Special Standard PUD Zoning District

Project Name: Mayberry Phase 2 **PCD File No.: PUDSP251**

DEVIATION REQUEST (Attach diagrams, figures, and other documentation to clarify request)

Deviation from the standards in Section 2.3.2 of the Engineering Criteria Manual (ECM) is requested. Describe the specific ECM standard for which a deviation is requested and state the reason for the deviation:

MAYBERRY DRIVE (FORMELY NEW LOG ROAD)
SECTION C-C AT COUPLET
APPROVED WITH MAYBERRY PHASE 1 PUD
DESIGN SPEED: 40 MPH
POSTED SPEED: 30 MPH
(MINOR ARTERIAL)
SCALE: 1" = 5'

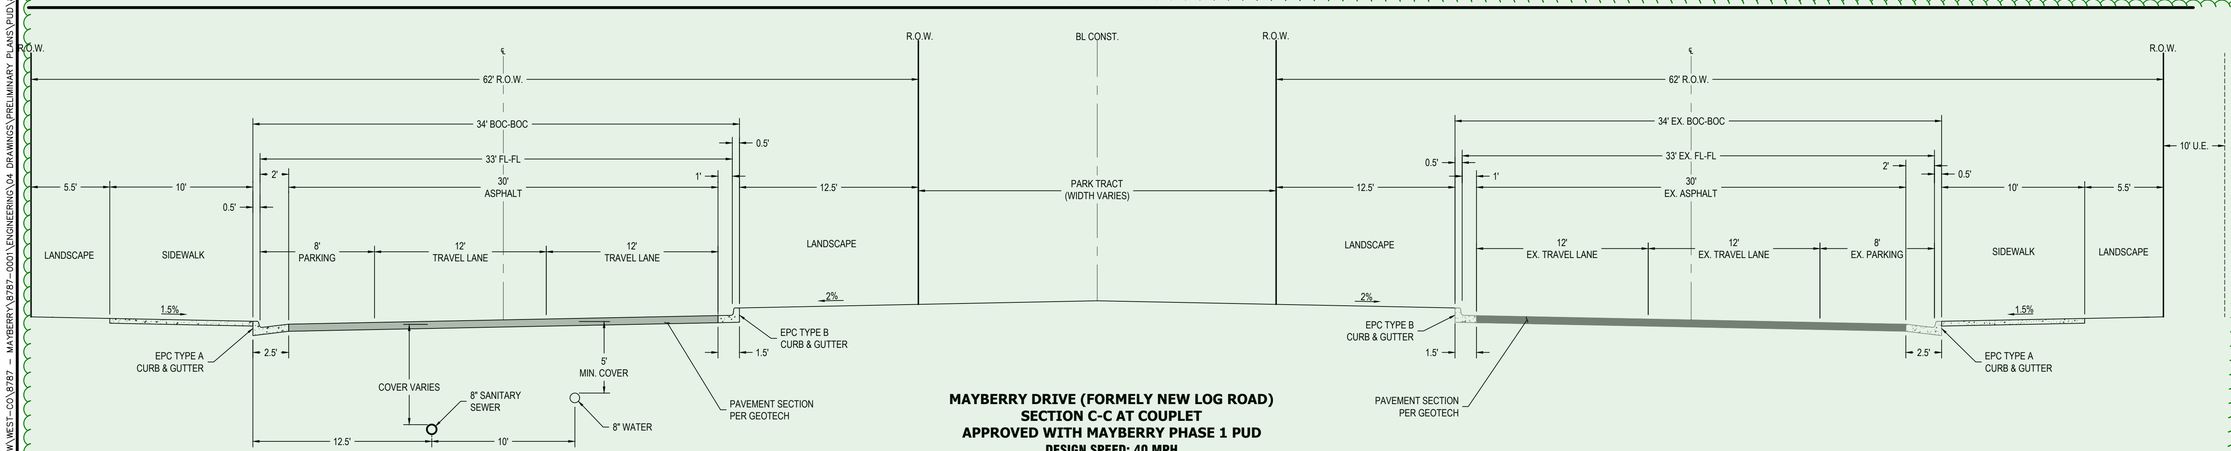
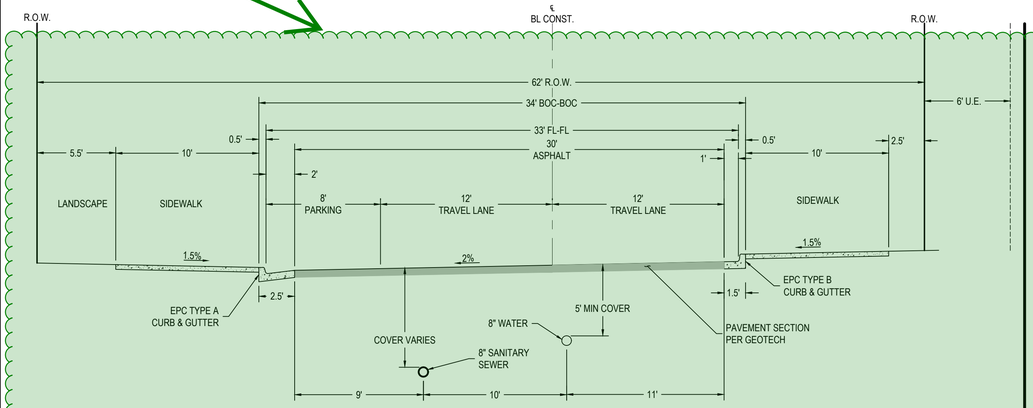
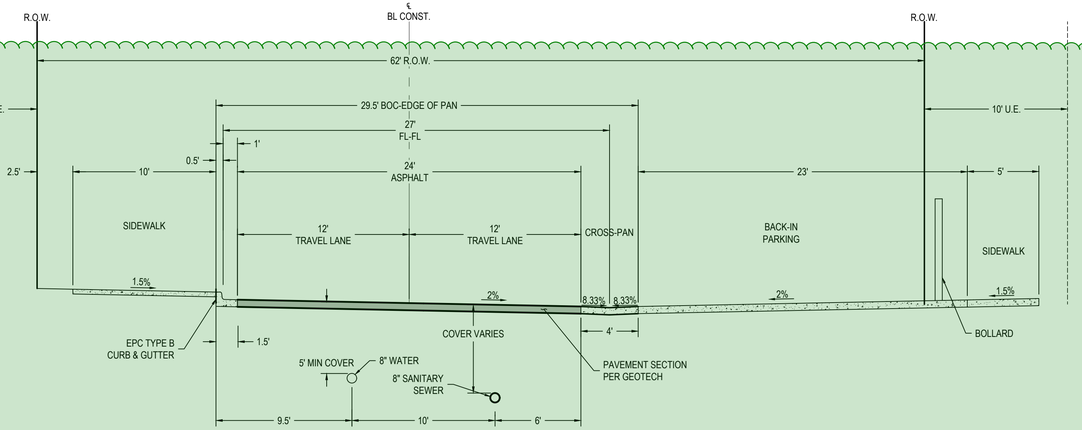
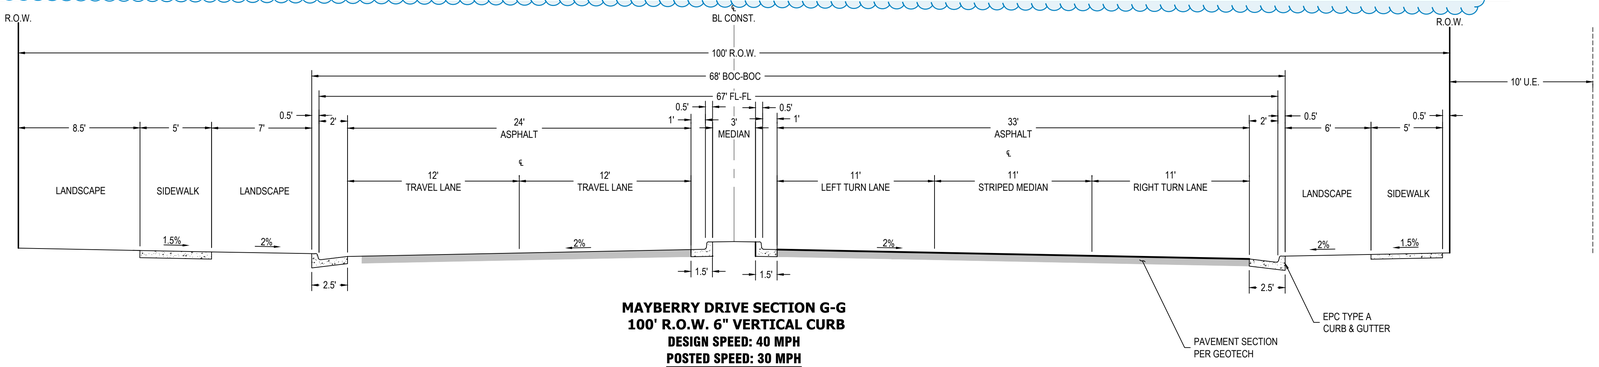
2. Detailed Deviation – Urban Minor Arterial (Mayberry Drive)
Applicable ECM Standard: ECM Section 2.3.2, Table 2-6 – Urban Minor Arterial, ECM Detail SD_2-5 Minor Collector

1. Provision for Two 12-ft lanes

2. Addition of 10-ft Attached Sidewalk along the western road of the couplet

3. Detached 5-ft Sidewalk on the northern side of the couplet
    a. Reduced from 6-ft section as shown on ECM Detail SD_2-5 for a Minor Arterial
        - The section of 5-ft walk is between SH 94 and the beginning of the attached 10-ft walk section.
        - Allows for a pleasing uniform scoring pattern between the 10-ft and 5-ft walk sections.
        - Expected to have limited pedestrian traffic between Mayberry community places and the state highway to the north that doesn't have a connection with east-west sidewalks.
        - The projected traffic volume of approximately 1,950 ADT remains well below the thresholds that would necessitate full arterial buildout and supports the proposed context-sensitive cross section.

4. Inclusion of Limited Parallel Parking
    - Parallel parking is introduced in select segments to:
        - Provide convenient, short-term parking for adjacent uses
        - Act as a buffer between vehicular traffic and pedestrians, improving perceived and actual safety
        - Support traffic calming by narrowing the apparent travel way
        - Enhance streetscape continuity and accessibility

5. Inclusion of Limited Diagonal Parking
    - Diagonal parking is incorporated in constrained, strategic areas to:
        - Increase parking efficiency where land uses generate higher demand
        - Activate the community park area and encourage pedestrian interaction with surrounding development

POSITIVE PLACE (FORMERLY MAYBERRY DRIVE) TYPICAL
BOULEVARD SECTION F-F
90' R.O.W. 6" VERTICAL CURB
AMENDED TO MAYBERRY PHASE 1 PUD
DESIGN SPEED: 30 MPH
POSTED SPEED: 25 MPH
(URBAN RESIDENTIAL COLLECTOR)
SCALE: 1" = 5'

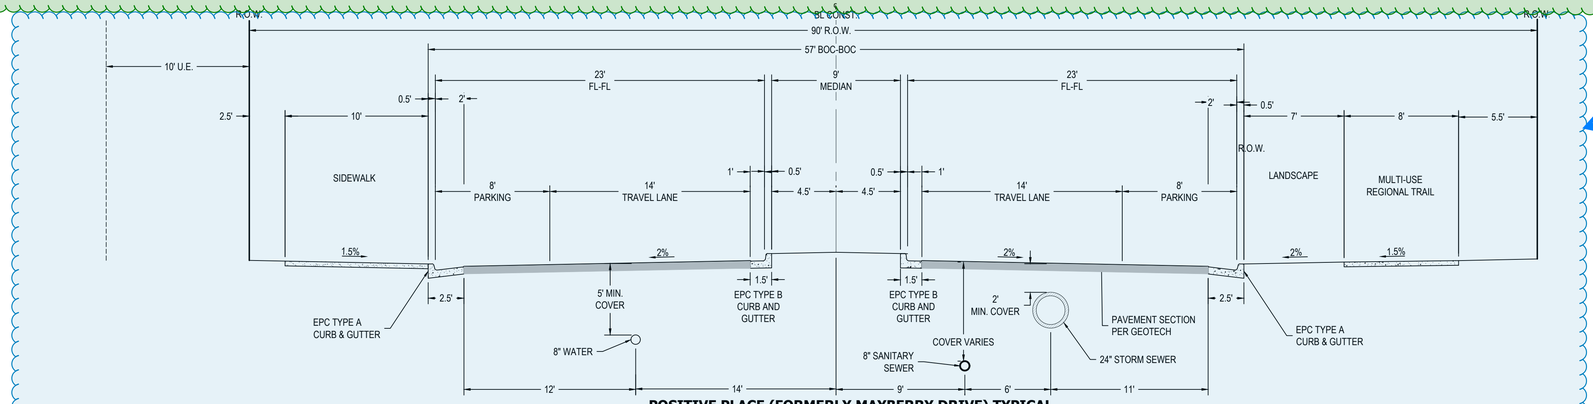
1. Detailed Deviation – Urban Residential Collector (Positive Place)

1. The proposed 90-foot right-of-way exceeds the ECM standard 60-foot Urban Residential Collector section, but is reduced from the 100-foot section previously approved within the Mayberry Phase 1 PUD.
   The ROW allows for:
   - Elimination of bike lanes in favor of alternative off-street multimodal facilities
   - Reallocation of space for on-street parallel parking and enhanced streetscape elements

The Phase 2 PUD updated section includes:

- 14-ft travel lanes
- 8-ft parking lanes

2. Attached 10-ft Sidewalk with Tree Wells
   - Replaces detached sidewalks to:
     - Enhance pedestrian connectivity and support walkable development patterns
     - Support adjacent community gathering areas and higher pedestrian activity
     - Enhance streetscape continuity and accessibility
     - Support on-street parking access to community features

3. Detached 8-ft Regional Trail
   - Integrated into the corridor to:
     - Accommodate a relocated County regional trail connection (in coordination with the County Park Board)
     - Provide an east-west multimodal corridor through the development
     - Maintain regional connectivity to Highway 94 and future trail extensions

PRIVATE DRIVE B SECTION H-H
35' TRACT 6" VERTICAL CURB AND 6" ROLL OVER CURB
CATTLEMEN VIEW
NO ONSTREET PARKING ALLOWED
DESIGN SPEED: 10 MPH
POSTED SPEED: 5MPH
SCALE: 1" = 5'

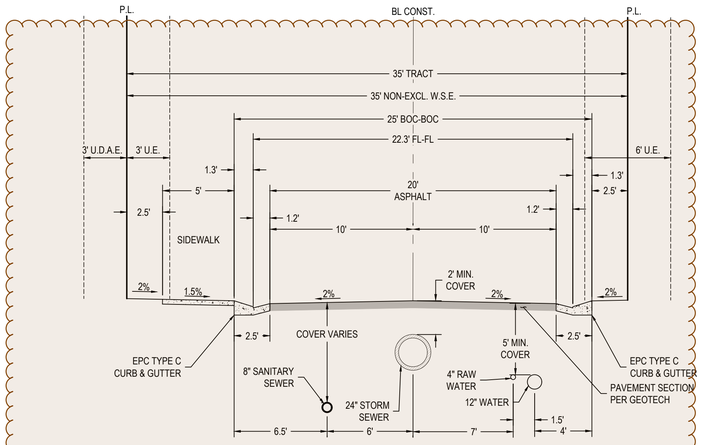
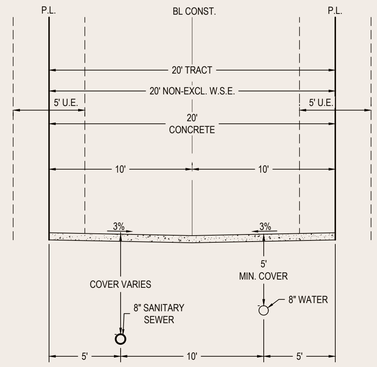
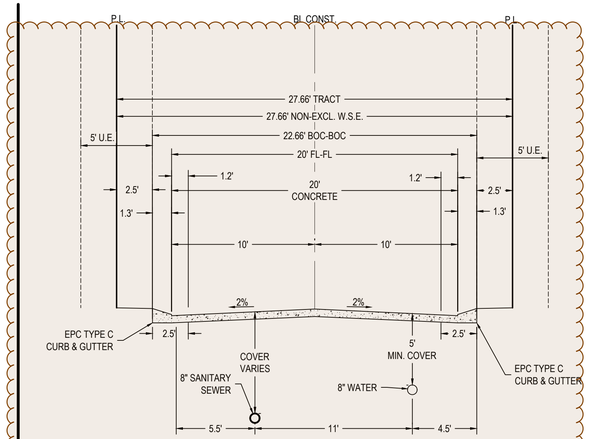
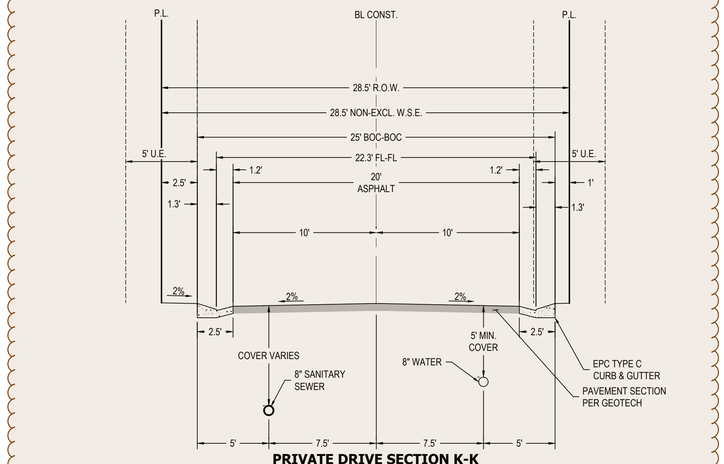
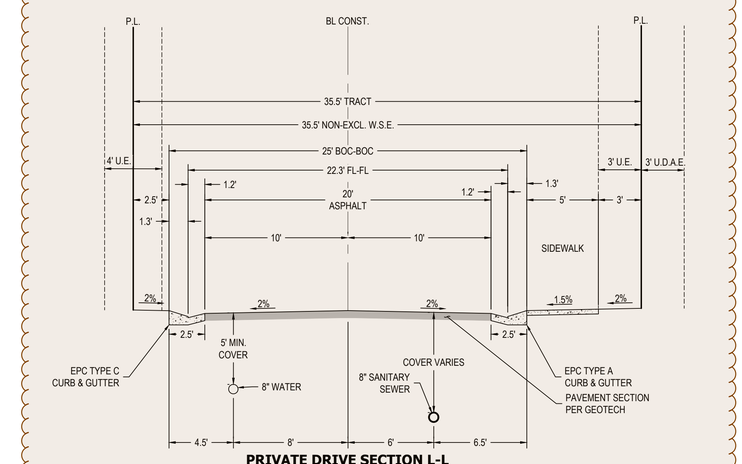
4. **Detailed Deviation – Private Roads within Tract K (Cattlemen View, Crossroads Point, Shade Tree Grove, Pasture View, Front Porch View, Town Green Point, and Gathering Point)**
   Applicable ECM Standard: ECM 2.3.2,Table 2-7 Roadway Design Standards for Urban Collectors and Locals, ECM 2.4.1.B Access Spacing and Table 2-33 Entering Sight Distance – Minimum Sight Distance Along Roadway

Proposed Modified Design:
1. Reduced and Variable Roadway Widths Consistent with Low-Speed Private Street Design
   - The proposed private roadway network within Tract K includes

- Variable-width roadway sections ranging from approximately 21 feet to 25 feet (asphalt with mountable curb).
     - Concrete sections 20 feet in width with inverted crowns.

- Crowned concrete section at Front Porch View, with mountable curbs to facilitate driveway access
   - In areas where head-in (90°) parking is provided, Town Green Point and Cattlemen View, roadway widths approach the standard:

- A minimum width of approximately 23.2 feet is provided in these locations, which functions similarly to the required 24-foot aisle width for urban low volume.

- Along the north side of Cattlemen View, back-up diagonal parking spaces are provided, which:
    - Require less maneuvering aisle width than traditional 90° parking
    - Further support the functionality of reduced-width travel ways

2. Driveway Access to Concrete Sections with Inverted Crowns
    - Select segments include 20-foot-wide concrete pavement sections with inverted crown profiles, allowing:
        - Direct and flexible driveway access throughout Tract K
            - These Private roads are identified as: Shade Tree Grove, Crossroads Point, Town Green Point, and Gathering Point
        - Improved drainage control within a compact cross section
        - A seamless transition between travel way and adjacent uses, reinforcing the shared-space concept

Proj. Name: Mayberry
Location: El Paso County, Colorado
Plan Set:
Sheet Name: WB-67 TRUCK TURN EXHIBIT

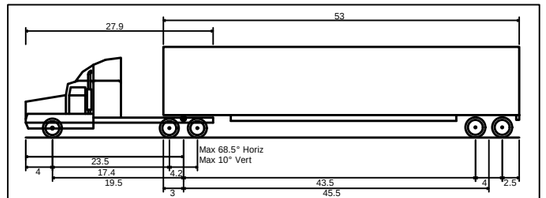
1. Inclusion of Intersection Bump-Outs (Curb Extensions)
   - A 35-ft radius is proposed at the bump-out locations
     - The proposed radius exceeds the 30-foot minimum curb return radius identified for Collector/Arterial intersections.

- The 35-foot radius accommodates required WB-67 design vehicle turning movements, as demonstrated in the attached AutoTURN exhibits.
   - Curb extensions are proposed at intersections along the Mayberry Drive couplet with Village Main Street & Positive Place, along with the intersection at Marketplace Drive to:
